Product change notification (PCN)

Title / short description	UL approval for PLC-H... items with 220DC output from the PLC-INTERFACE product range
Affected article category	Relay modules
Change category	Approval, Marking
Change number	CCK230151-00
Reason for PCN/PDN Revision

Addition of UL approval for the PLC-H...-24DC/220DC/10 versions

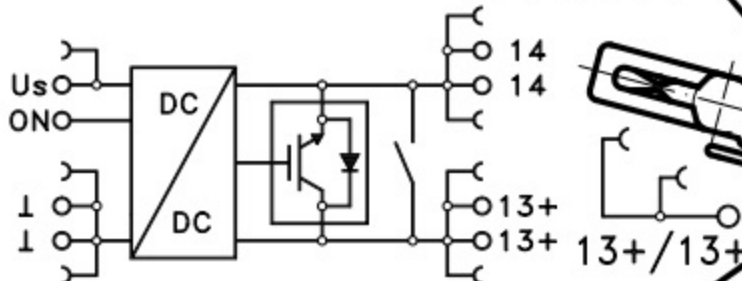
With UL approval for the PLC-H...-24DC/220DC/10 items (see item list) from the PLC-INTERFACE product range being obtained, changes are being made to the print image and the documentation. The printing change can be seen in the attached images (see "Old.jpg" and "New.jpg"). The PLC-H...-24DC/220DC/10 items are a combination of relays and solid-state relays with DC hybrid output.

V/C and visual features (see images)
